## **BID ADDENDUM NO. 4**

October 01, 2018

### **Johnson Student Center**

### **Building Demolition, Increment 1 (Demolition) and Increment 2**

**SHEET NUMBER**  
C1.00

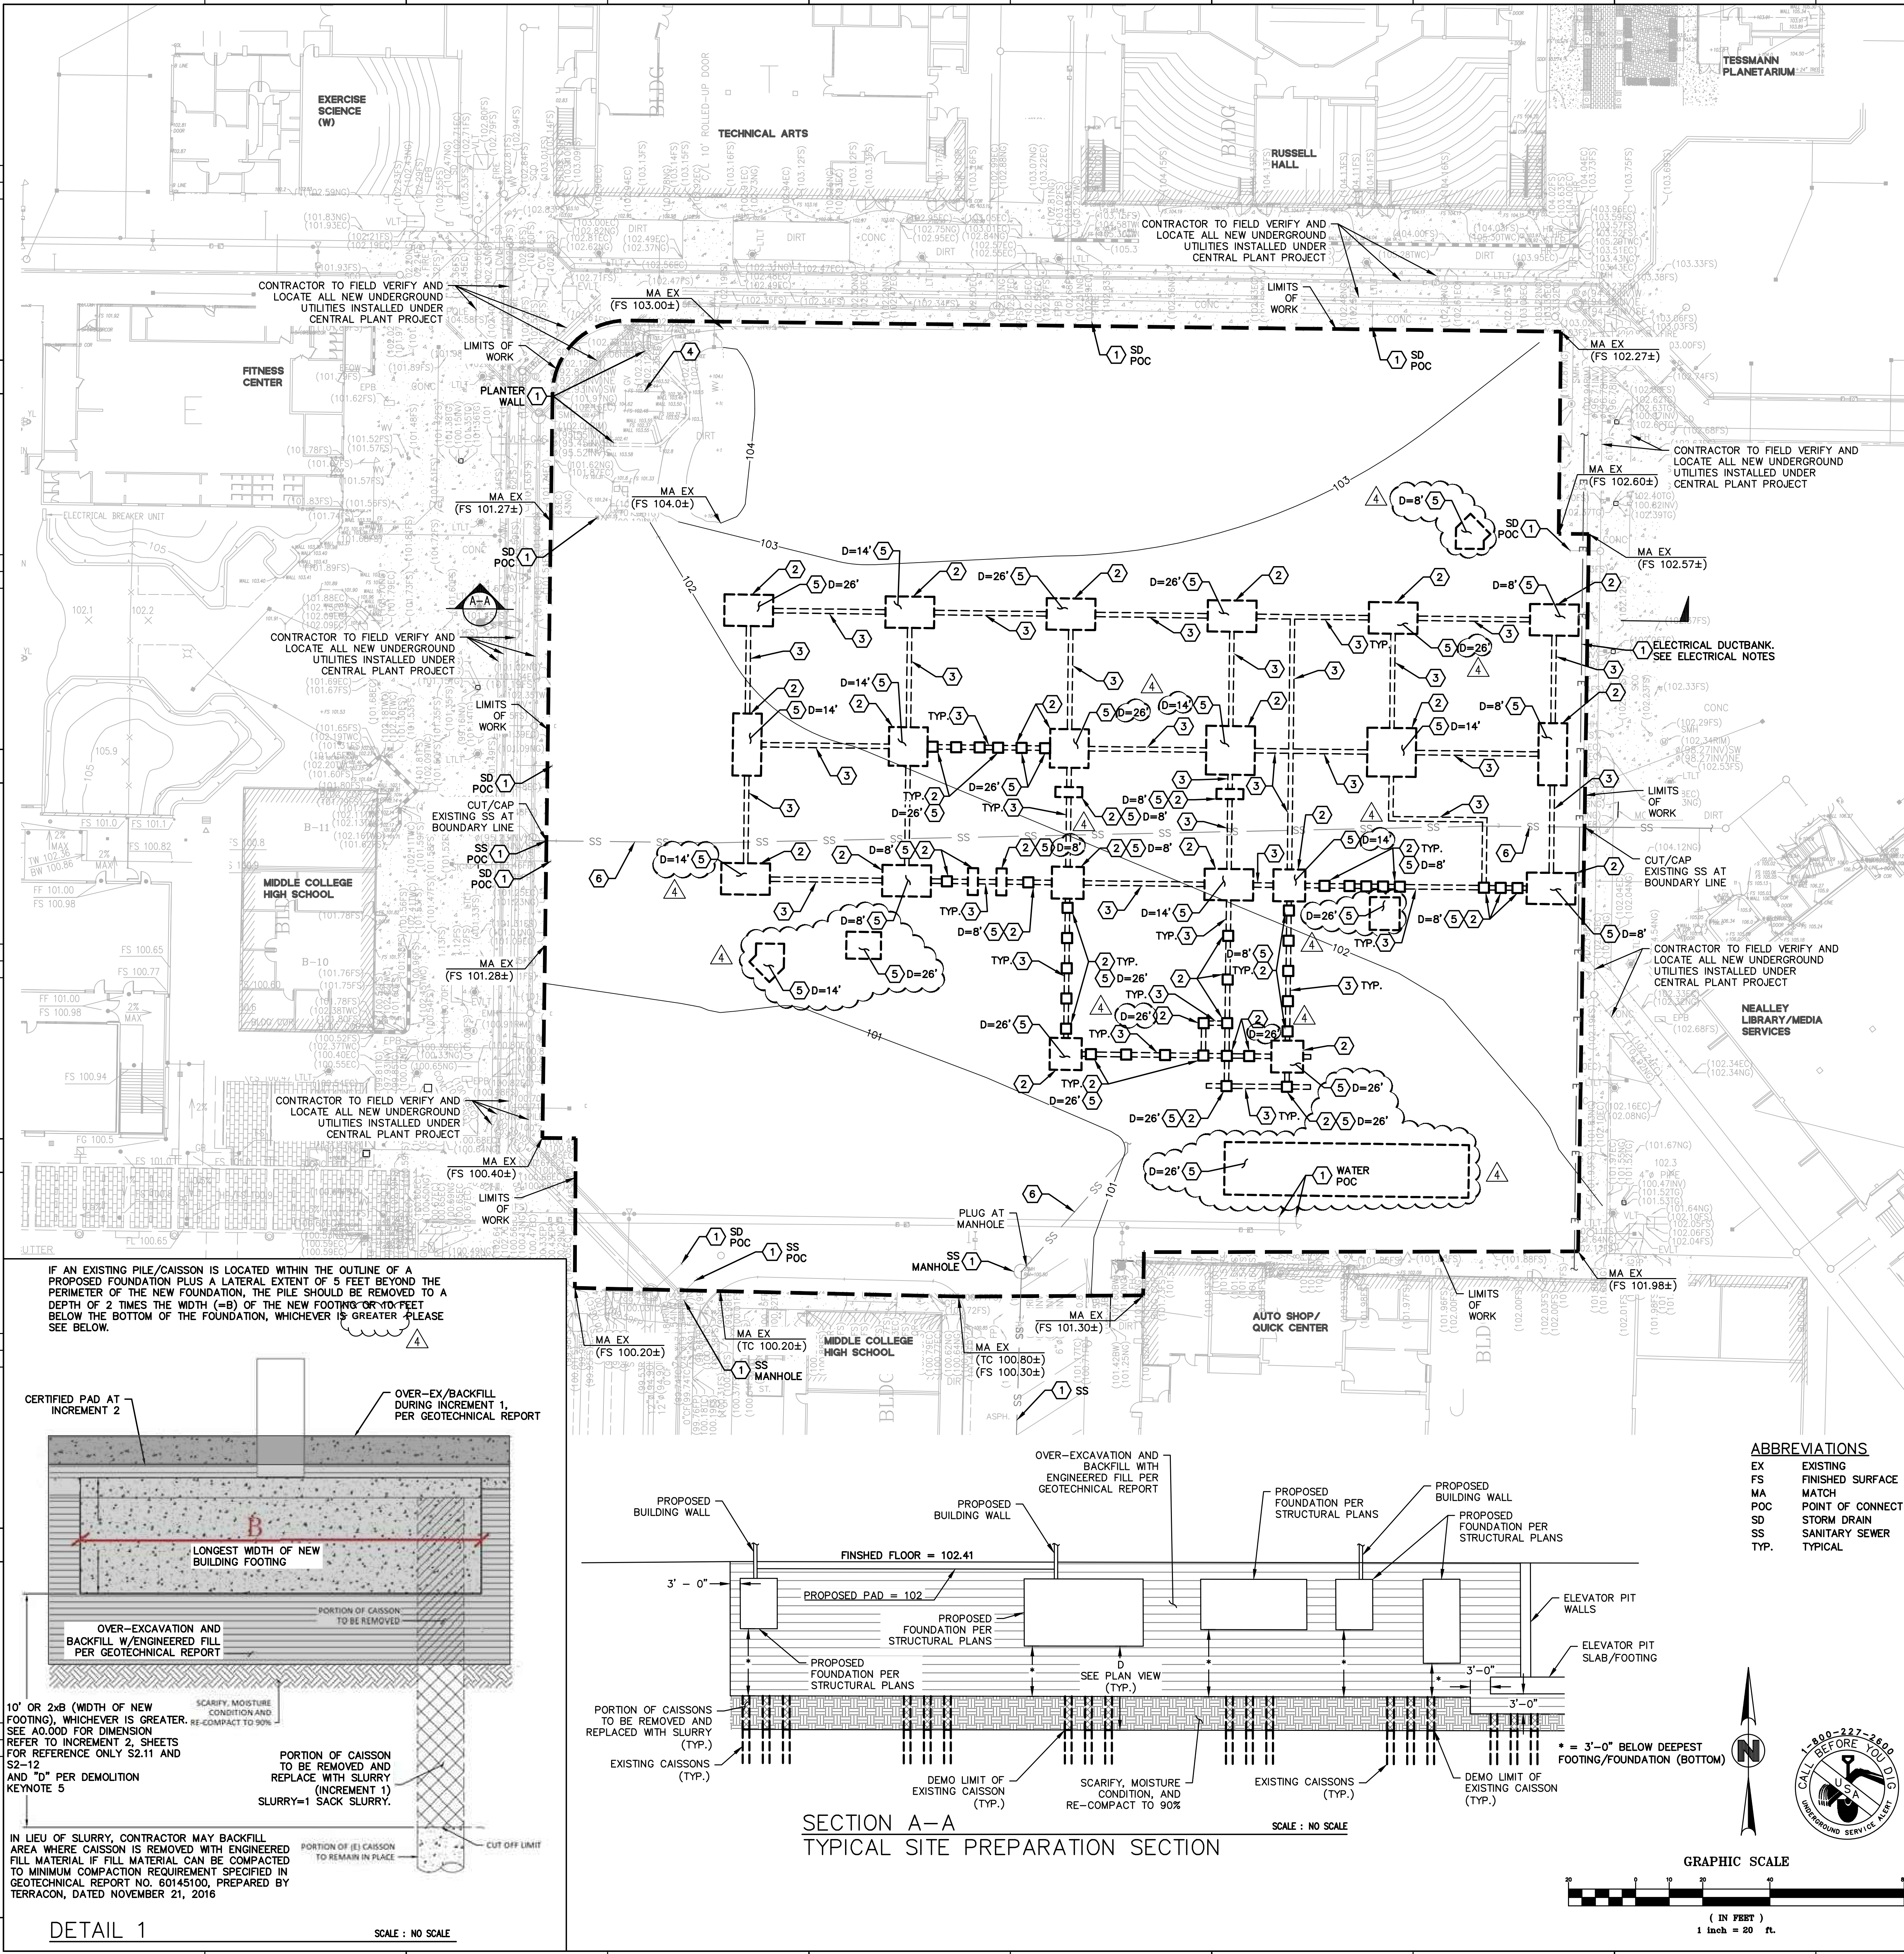
- Building Demolition
  - i. Re-issue of sheet C1.00 (addendum 3), refer to clouds and delta 4
    - 1. Refer to landscape, hardscape, underground wet/dry utilities being removed/demoed in their entirety in lieu of being protected.
    - 2. Revised/removed notes as needed for phasing of work with increment 1 and 2.
- Increment 1
  - i. Revised pile depth demolition to reflect Architectural sheet A0.00D. Refer to attached full size sheet C1.0-D.
  - ii. Revised language at Detail 1 “of the foundation, whichever is greater...”

**Bldg Demolition Set to be revised and to match Inc 1 & 2. Refer to Addendum 3, revised Building Demolition Package sheet C1.00.**

C3.0

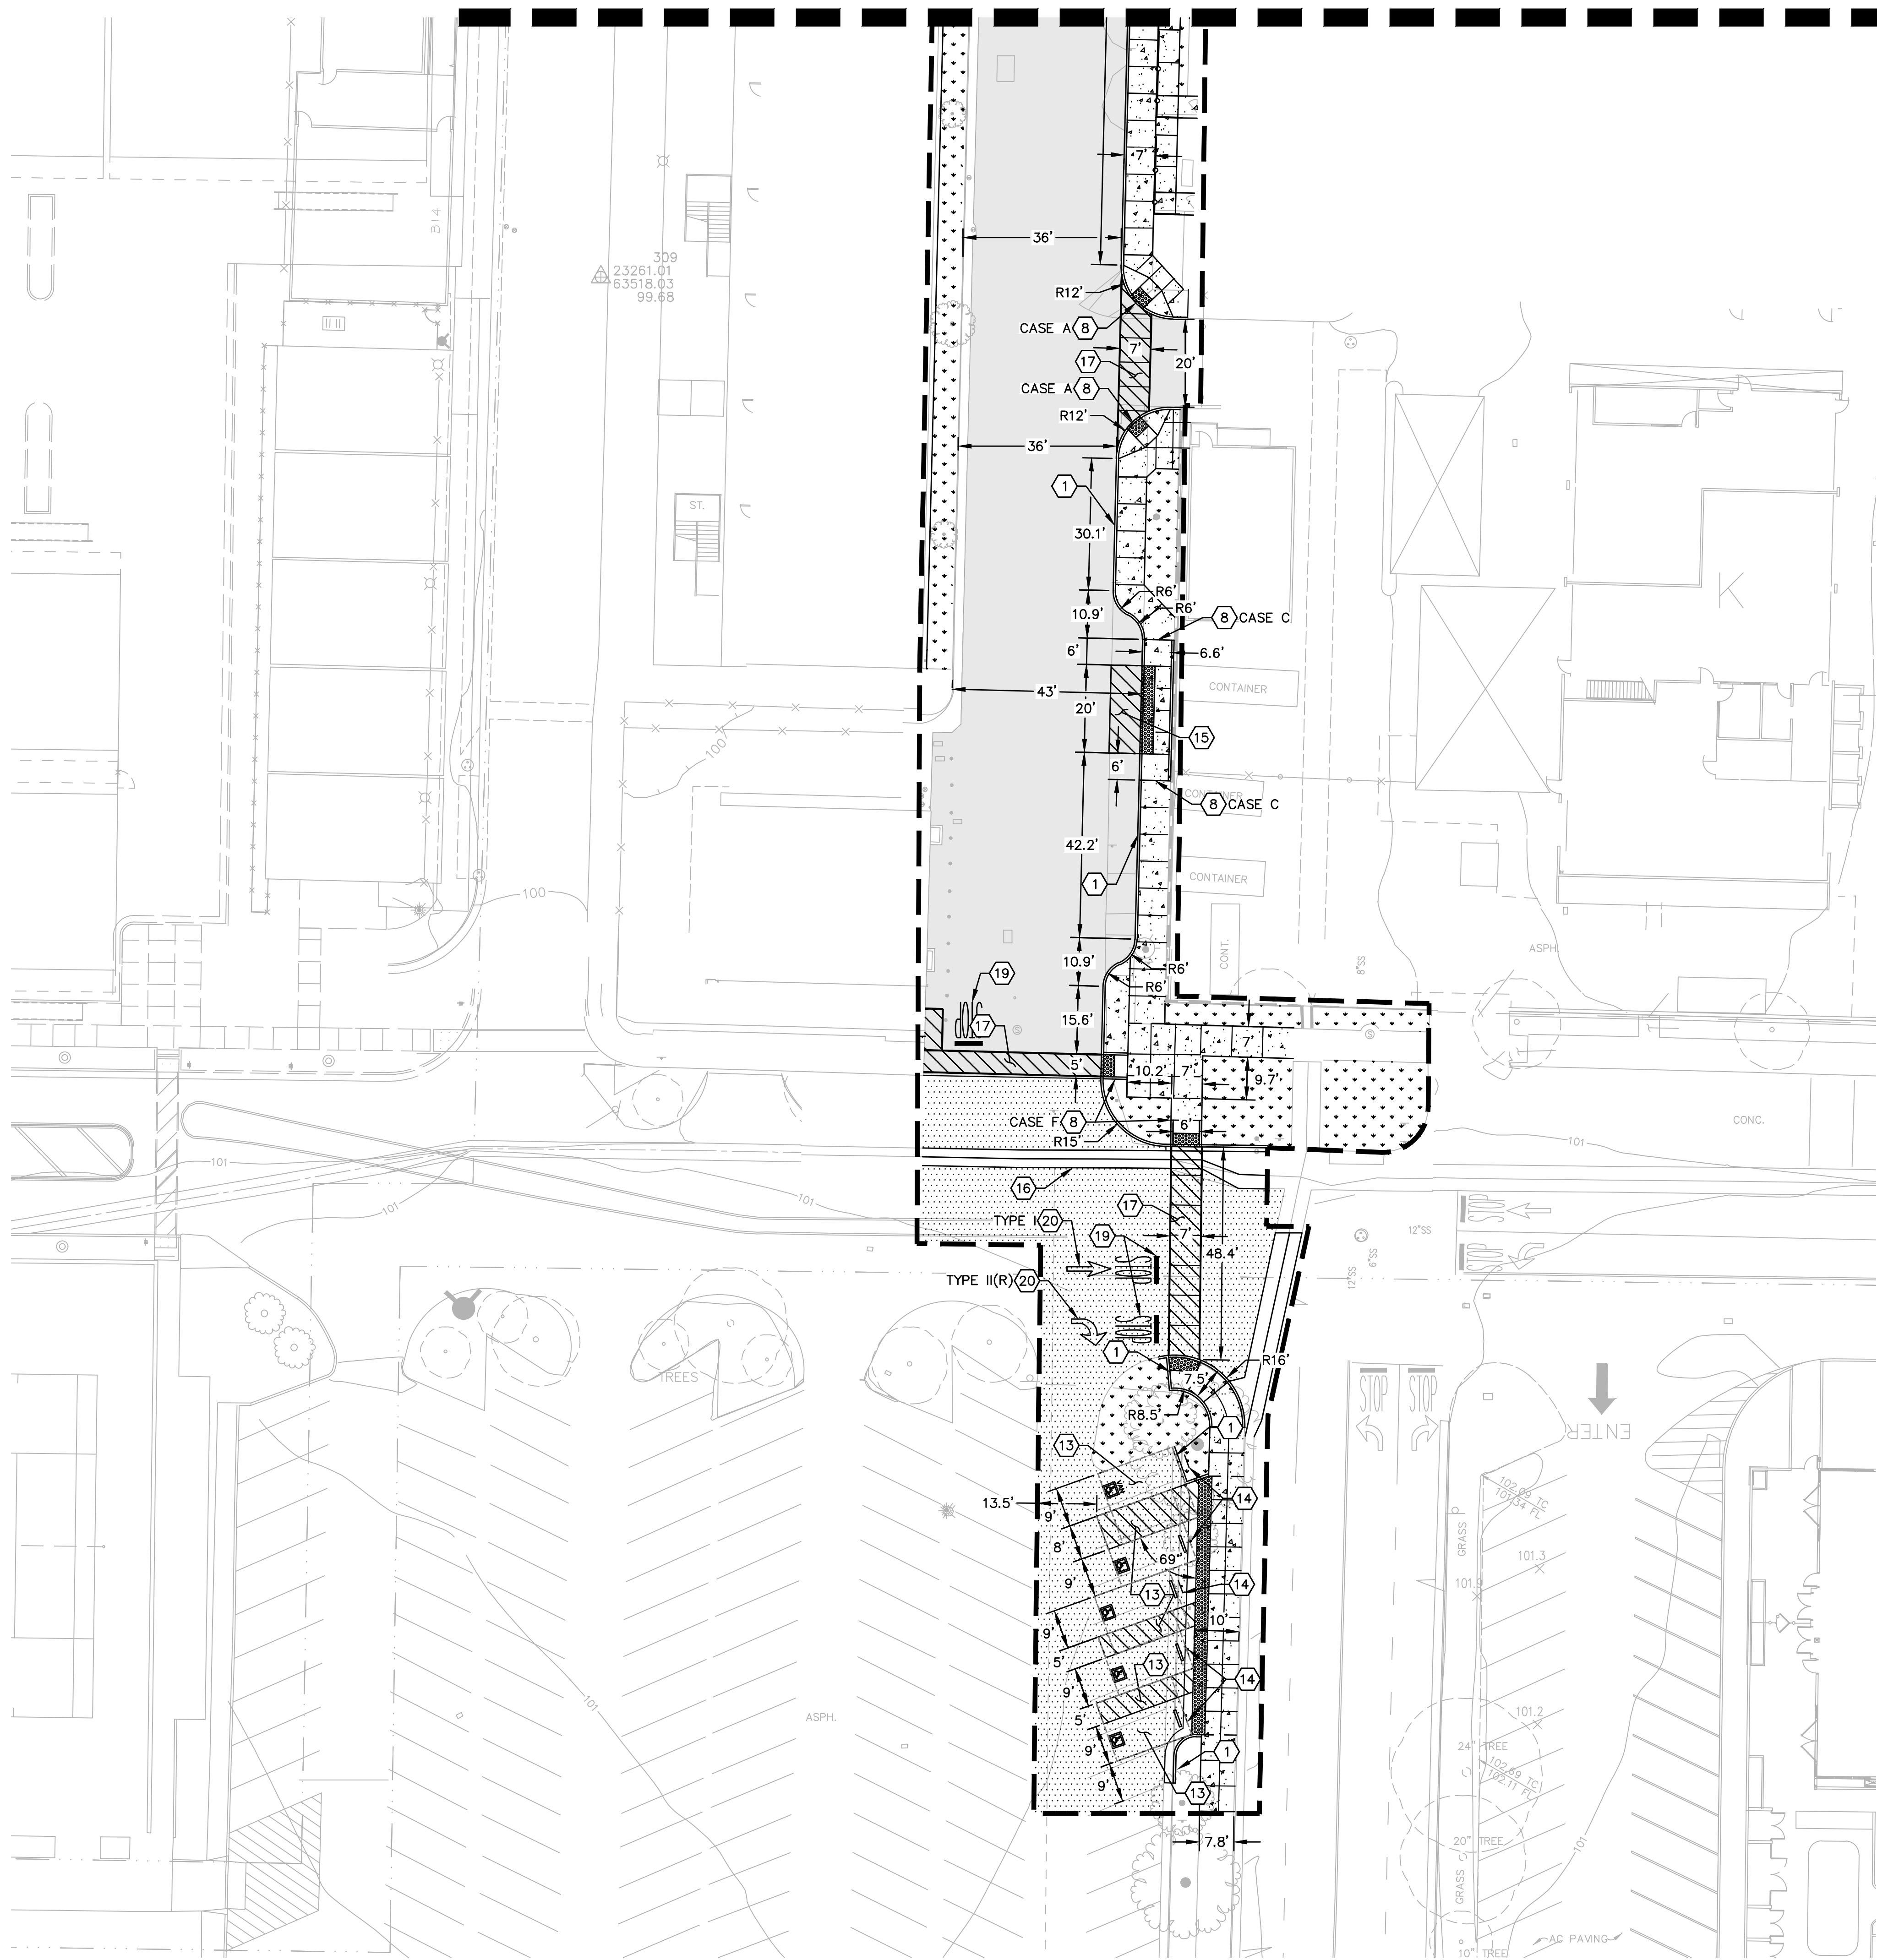
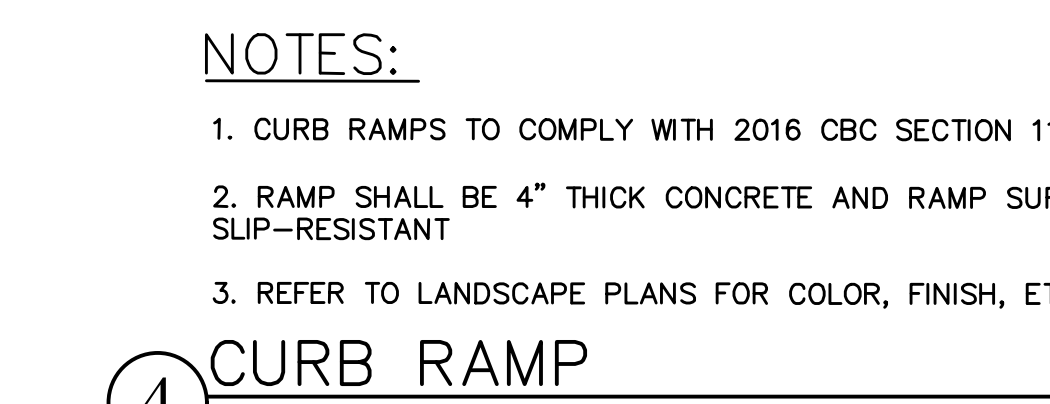
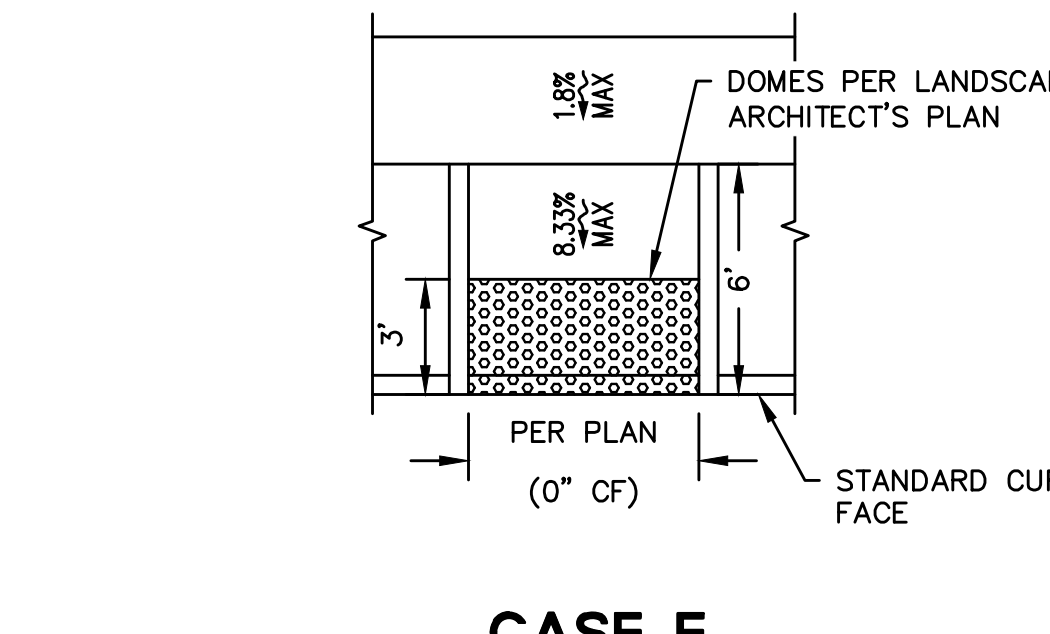
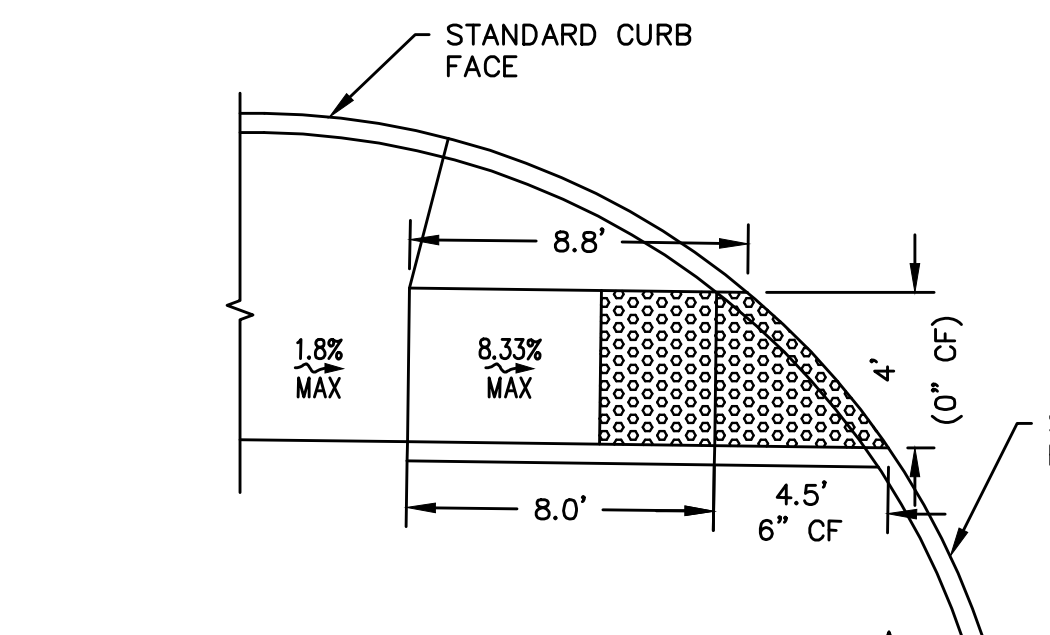
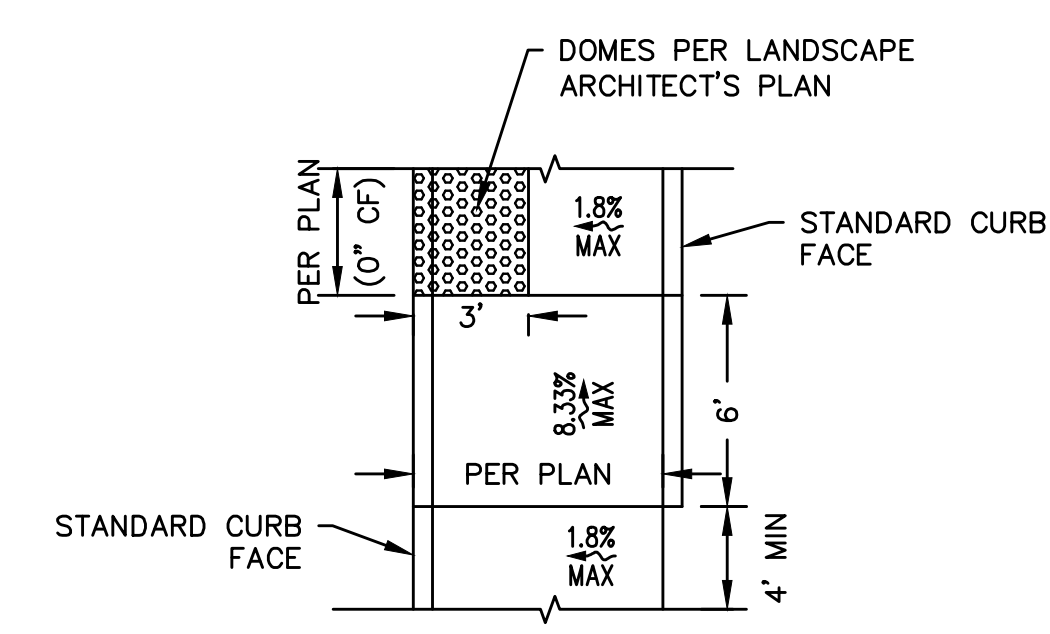
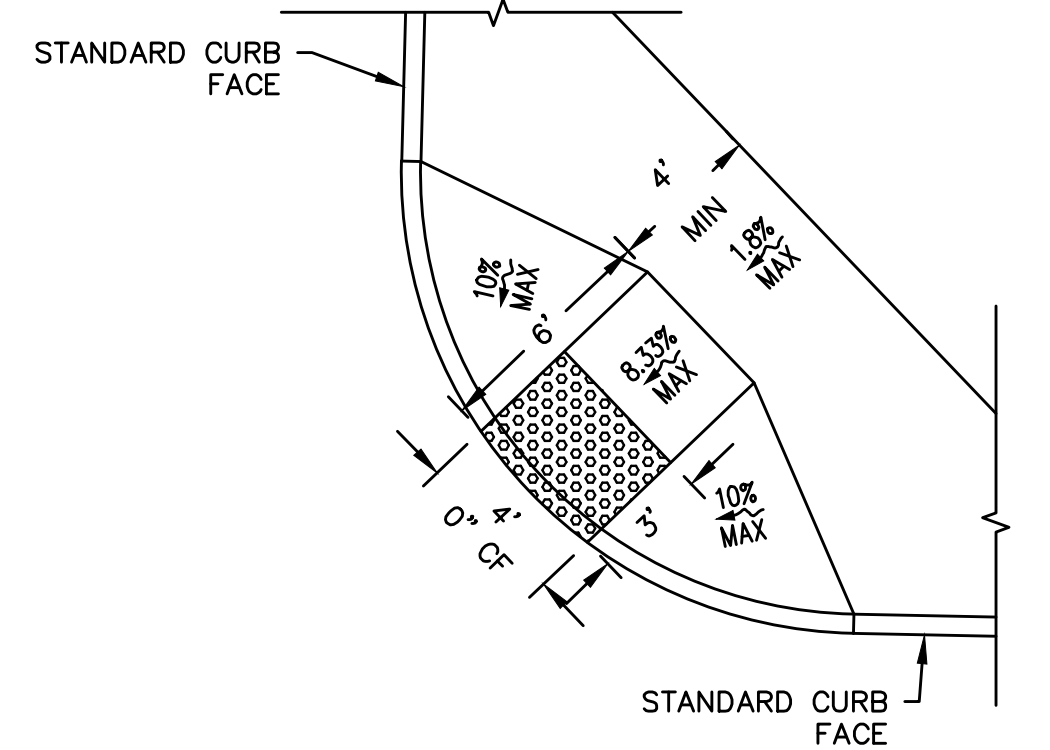
DATE:	09/18/2018		
FROM:	S.Monsen - McCarthy	EMAIL:	SMonsen@McCarthy.com
SPECIFICATION NUMBER:		DRAWING NUMBER:	C3.0 & C3.1
REQUESTED CLARIFICATION:			
Increment #2 - Sheets C3.0 & C3.1 - Horizontal Control Keynote 18 Rolled Curb was not located on these sheets. If required, provide the callout & locations for this keynote, or list this note as "not used" on this sheet.			
RESPONSE TO CLARIFICATION, <b>SUBMITTED AS PART OF AN ADDENDUM:</b>			
Keynote 18 revised to "Not used"			
RESPONSE PROVIDED BY:	Stuart Szuch, BKF Engineers	DATE:	10/01/18

- ⑰ INSTALL CROSSWALK STRIPING PER DETAIL 12, SEE SHEET C7.0
- ⑱ NOT USED
- ⑲ INSTALL STOP, STOP BAR, AND STOP SIGN PER SPPWC STD PLAN 172-0
- ⑳ INSTALL PAVEMENT ARROW PER SPPWC STD. PLAN 171-0, TYPE PER PLAN
